**COMMISSION OF ARCHITECTURAL REVIEW  
STAFF REPORT  
March 28, 2017, Meeting**

14. **CAR No. 17-047** (T. Schaaf)

**1208 West Franklin Street  
Monument Avenue Old and Historic District**

**Project Description:** **Reconstruct front porch, roof balustrade and fence, replace front second story doors.**

1208 W. Franklin Street, 1969 or 1970, showing the missing roof balustrade

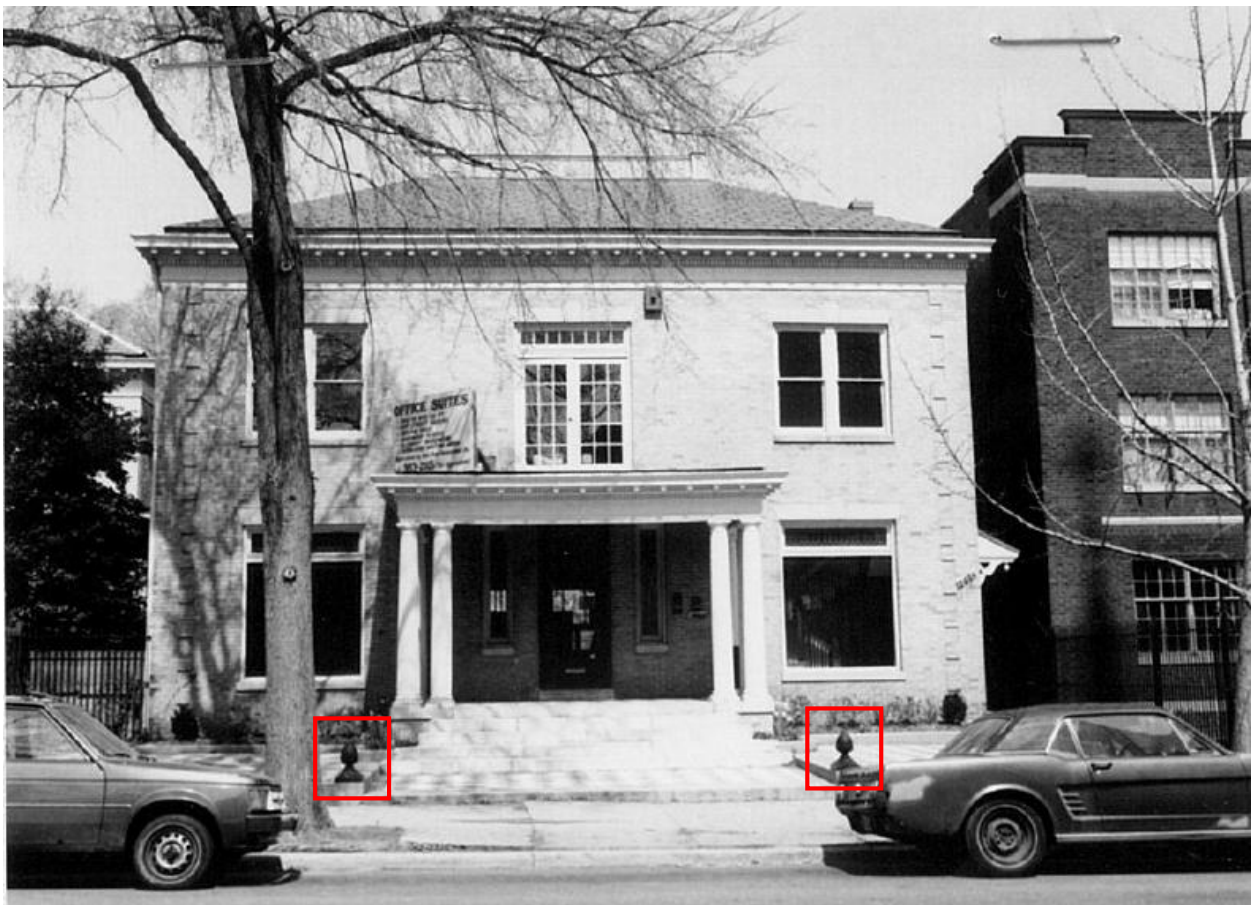
Documentation also exists for the proposed reconstruction of the roof balustrade. The applicant has supplied the original house plans which show the balustrade design and has stated physical evidence of the balustrade can be found on the roof. The applicant proposes to install a balustrade that matches the new porch balustrade. Staff has found photographic evidence of the missing roof balustrade,

which matches the design shown in the house plans. The *Guidelines* state that documentation should be used to reconstruct missing elements (pg. 57, #7). As sufficient documentation of the missing balustrade exists, staff recommends that the roof balustrade be designed to match the photographic and historical documentation, rather than the new porch balustrade design.
